4L60/65/70E

PUMP & INPUT SHAFT USAGE

Technical Service Information

Figure 1

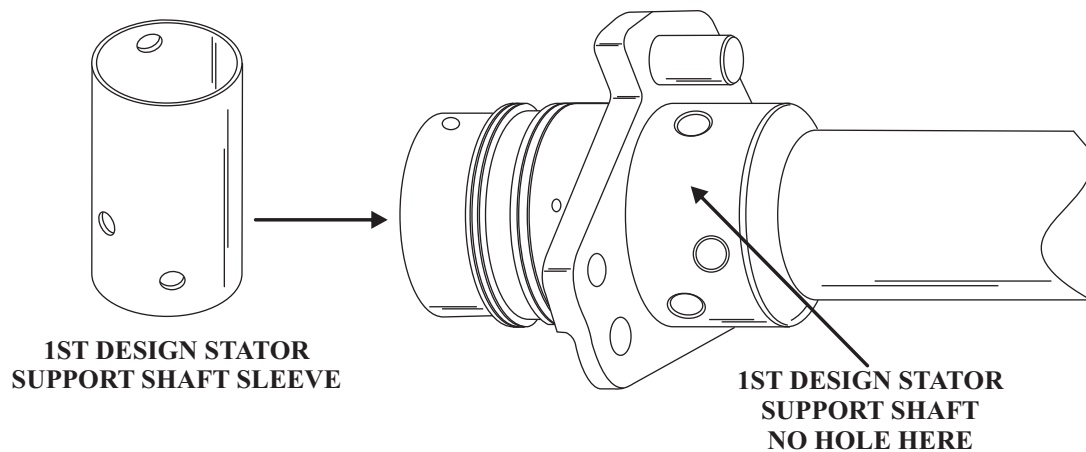
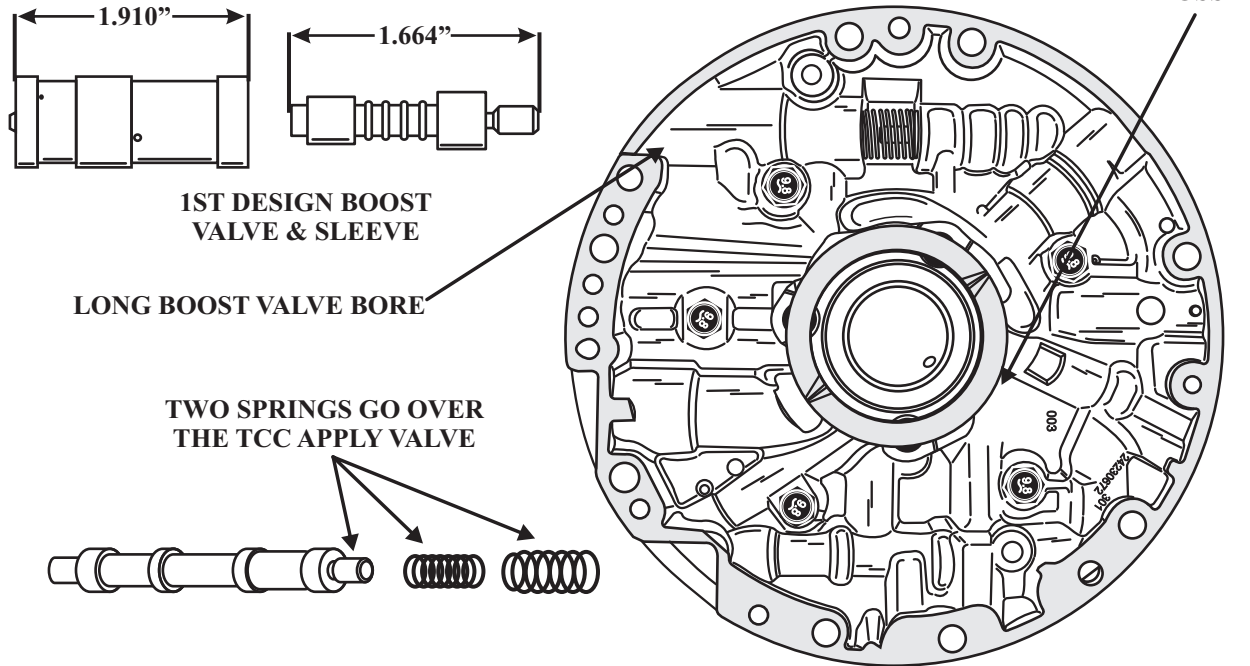
(1) In model years 1997 to early 2005, the 4L60E series transmissions utilized a pump cover with no provisions for an ISS, the input shaft sealing ring grooves had not changed and there was no speed sensor rotor. The pump cover used the 1st design internal stator shaft sleeve and the 1st design boost valve which is 1.664" with a boost valve sleeve of 1.910" in length as well as two springs that went on the TCC apply valve, (Refer to Figure 1).

Figure 2

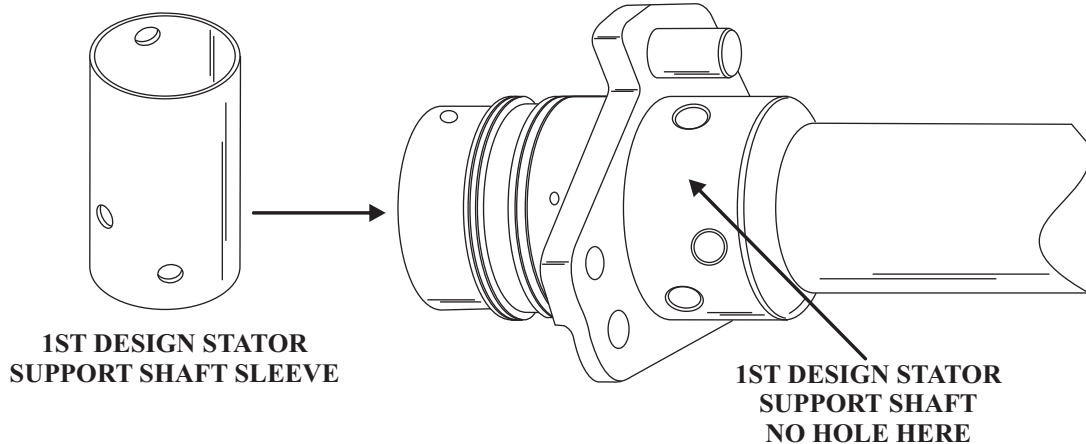
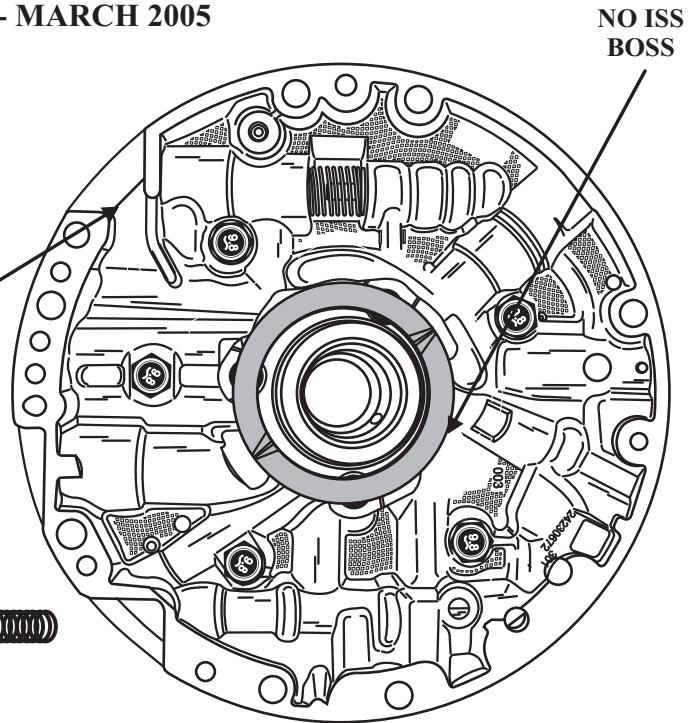
(2) Effective February 1st, 2005, the oil pump cover now uses a new design TCC valve with a single spring, (Refer to Figure 2).

(3) Effective March 7th, 2005, the oil pump cover now uses a more compact boost valve and sleeve. The snap ring groove location for the boost sleeve is now situated 2.57" from the bottom of the bore compared to 2.68" for the previous design. The bore length for the boost sleeve and snap ring has been reduced by approximately 0.110", also seen in Figure 2.

THE BOOST VALVE BORE
HAS BEEN SHORTENED .106"

ONE SPRING GOES INTO
THE TCC APPLY VALVE

Figure 3

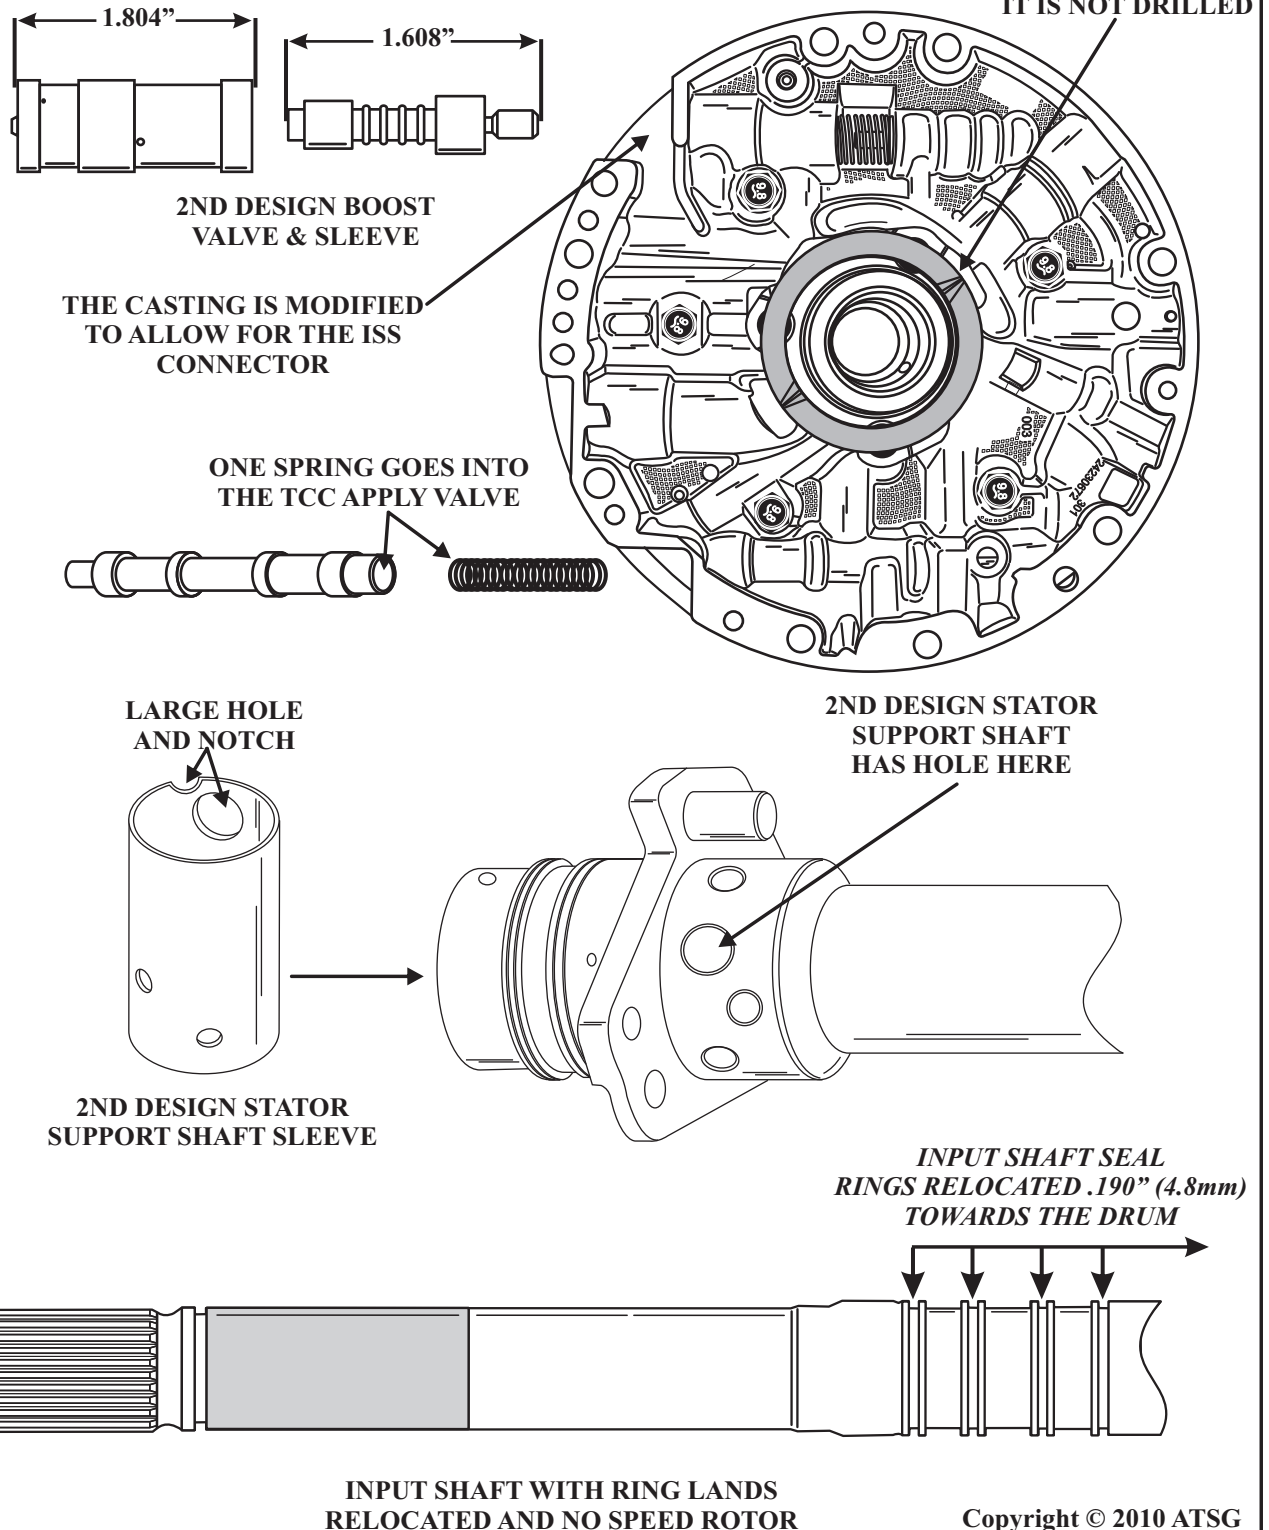
(4) After July 16th, 2005, the pump cover casting was modified in order to situate the ISS connector. This modification removed metal directly below the PR valve and boost sleeve bore and extended a cast wall inward. The internal TCC release passage was also modified at this time. The ISS mounting holes are not yet machined into the oil pump cover, (Refer to Figure 3).

At the same time, the turbine shaft oil seal ring grooves were moved inboard towards the rear of the unit approximately 0.190"(in.) to produce an area with which to manufacture 15 rotor teeth, this can also be seen in Figure 3.

Figure 4

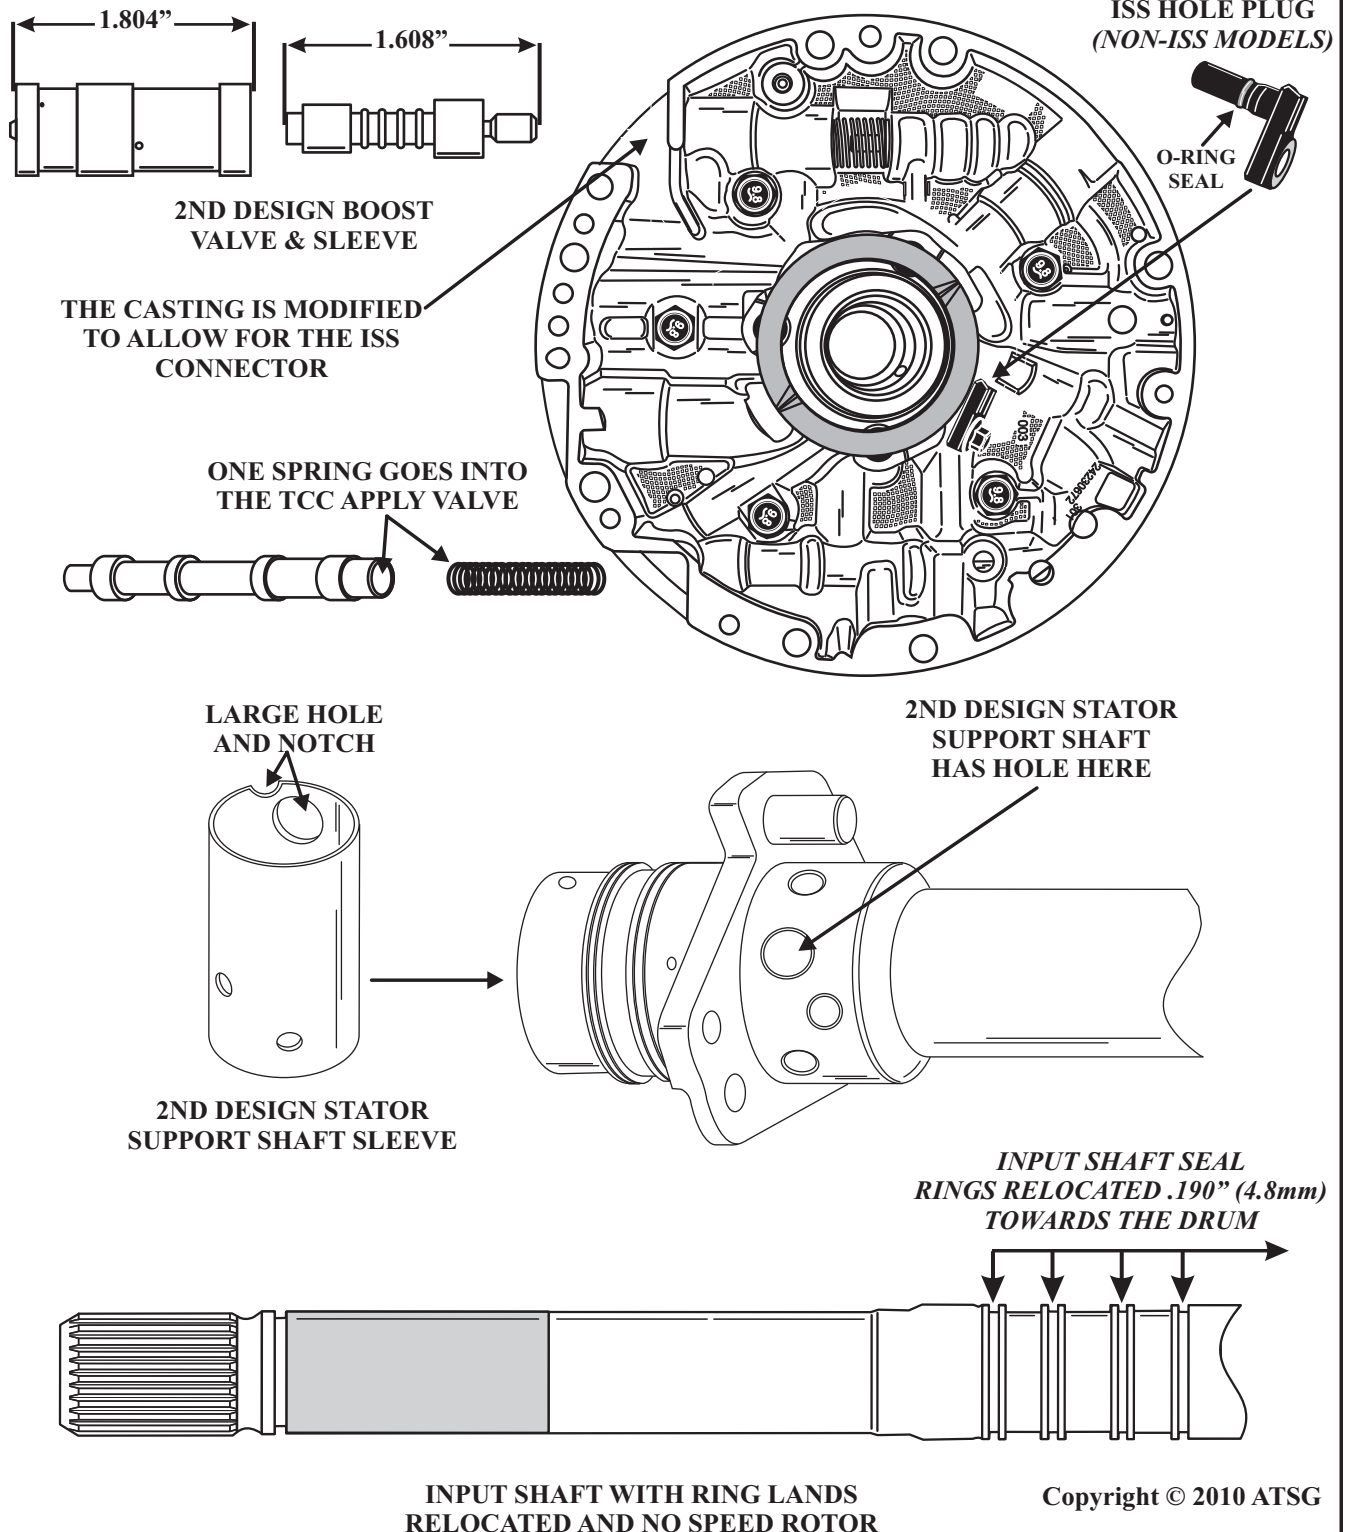
continued: (4) Late in 2005 and early in the 2006 model year, some pre ISS models may still not have the ISS mounting holes machined into the cover. This will be evident as a smooth un-machined surface without the ISS mounting holes. For non ISS models, an ISS hole plug will be used in place of the ISS assembly, (Refer to Figure 4).

On Non-ISS models that have a functional ISS hole in the pump cover, the rubber plug with an o-ring seal must be installed. Failure to do so will result in no converter charge and the vehicle will not move.

Figure 5

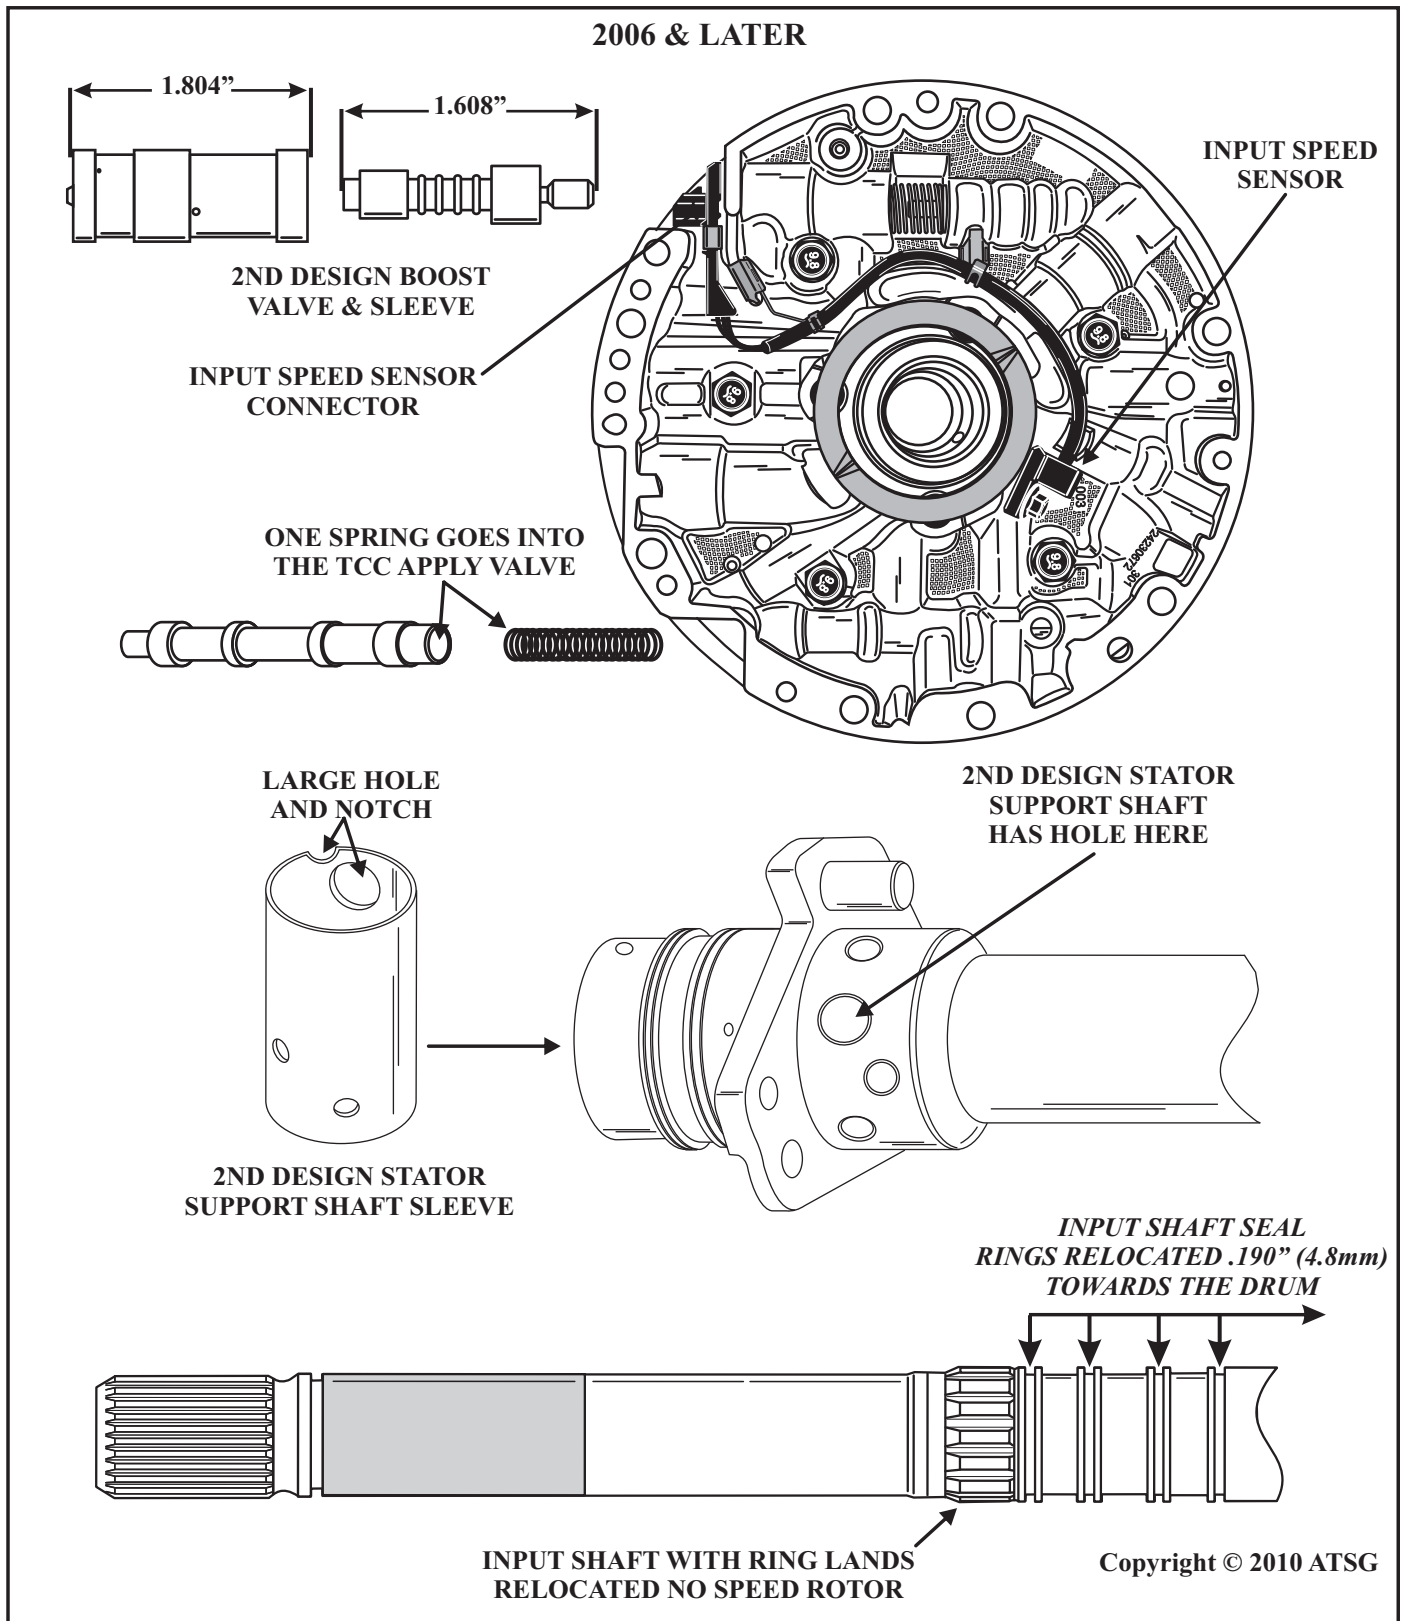
As ISS models were introduced, later in the 2006 model year, the machining took place and the input speed sensor (ISS) was added, (Refer to Figure 5), the presence of the ISS also necessitated a new internal wire harness to accommodate the ISS and software changes to the PCM provided code capability for ISS malfunctions.
